SERIAL: NLS-86-273

SHEARON HARRIS NUCLEAR POWER PLANT UNIT NO. 1 - DOCKET NO. 50-400 COMMENTS ON FINAL DRAFT TECHNICAL SPECIFICATIONS

Carolina Power & Light Company (CP&L) submits comments on the Final Draft Technical Specifications (TS) for the Shearon Harris Nuclear Power Plant (SHNPP). Attachment 1 provides 72 comments (record numbers 700 through 778 with the exception of record numbers 709, 711-715, and 717) on the TS as well as a justification for each comment. Attachment 2 provides a marked-up copy of the TS pages for each of the comments provided in Attachment 1.

FIGURE 3.4-4

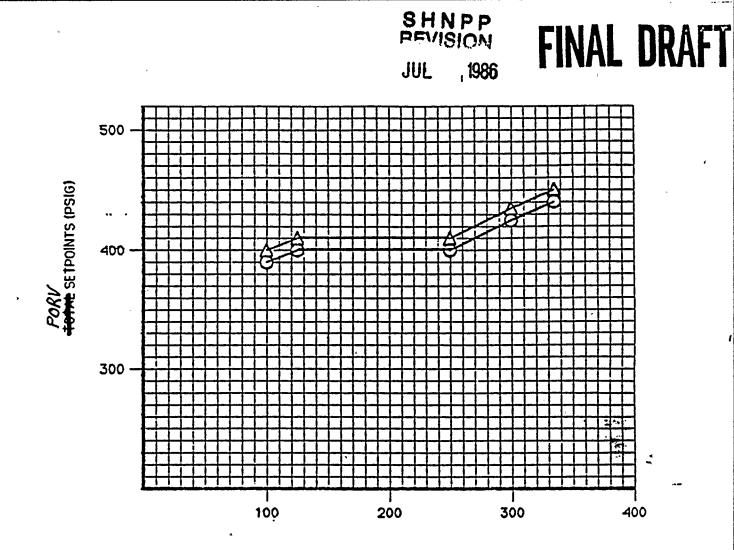
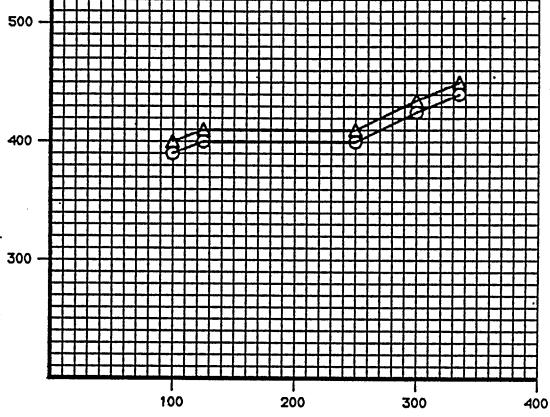
Section Number: FIGURE 3.4-4

CHANGE THE Y-AXIS LABEL OF THE GRAPH TO "PORV SETPOINTS (psig)".

THIS CHANGE IS TO CORRECT A TYPOGRAPHICAL ERROR IN THE ORIGINAL INFORMATION SUPPLIED BY CP&L.

FIGURE 6.2-1

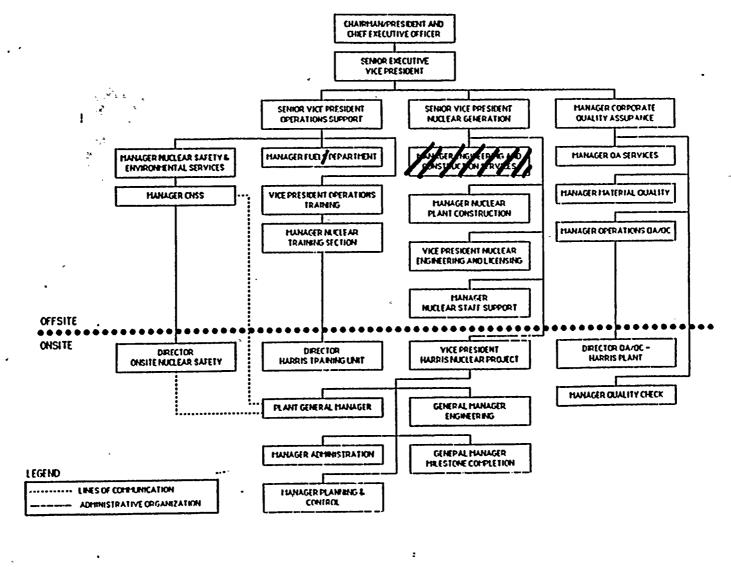
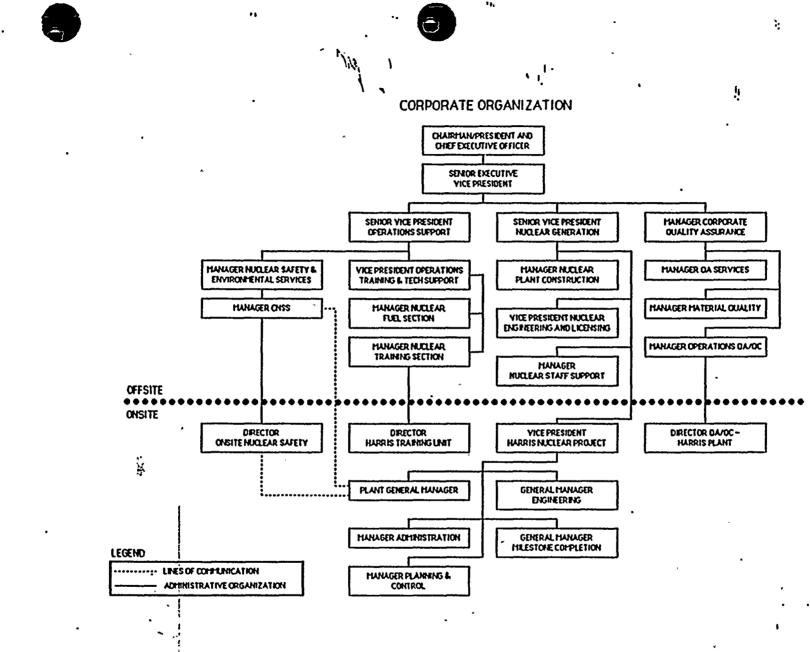
Section Number: FIGURE 6.2-1

DELETE THE BLOCK FOR "MANAGER ENGINEERING AND CONSTRUCTION SERVICES". ALSO, REMOVE THE "s" FOR THE TITLE OF THE MANAGER FUEL"S" DEPARTMENT.

THESE CHANGES ARE TO CORRECT A TYPOGRAPHICAL ERROR AND TO DELETE A POSITION WHICH NO LONGER EXISTS WITHIN THE ORGANIZATION

yest fre FIGURE 6.2-2 UNIT ORGANIZATION

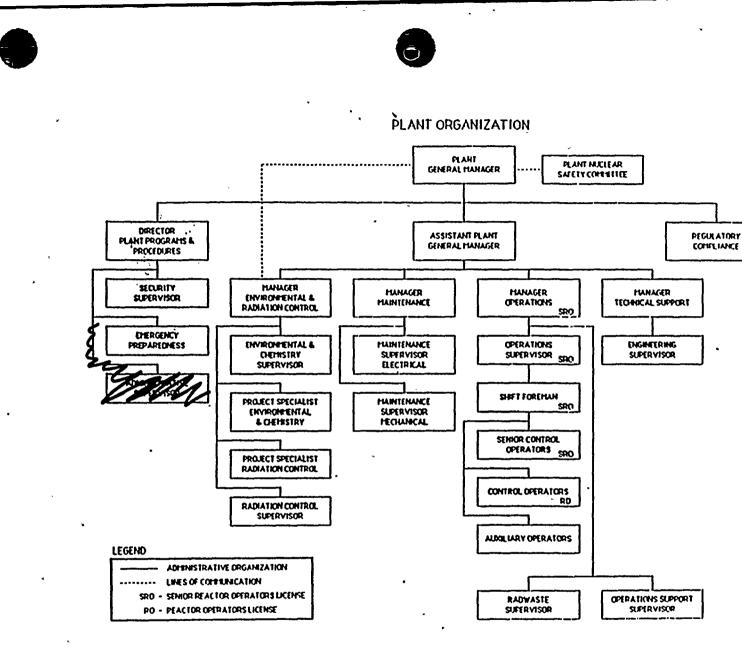
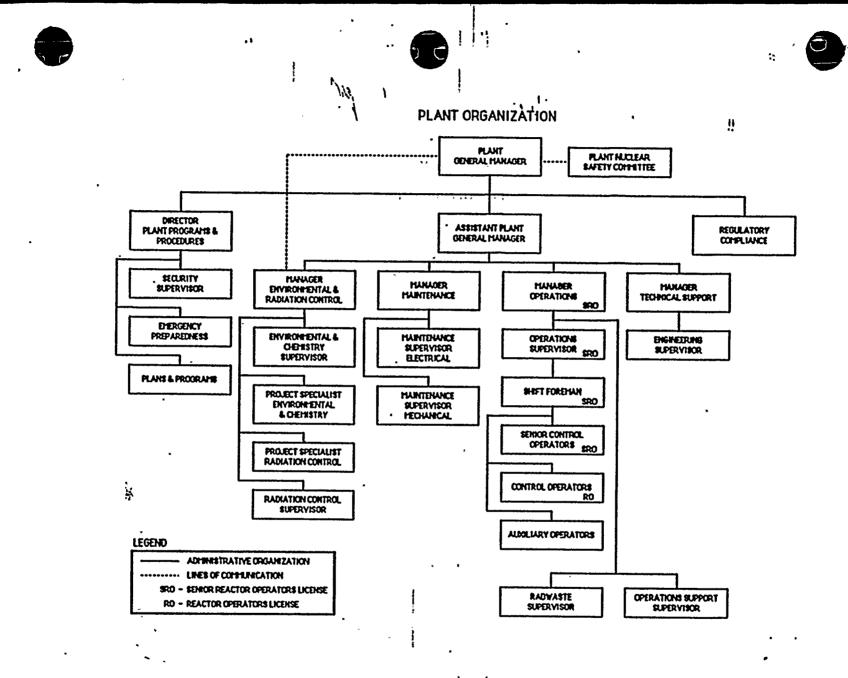
Section Number: FIGURE 6.2-2

DELETE THE BLOCK FOR THE ADMINISTRATIVE SUPERVISOR WHICH REPORTS TO THE DIRECTOR PROGRAMS & PROCEDURES.
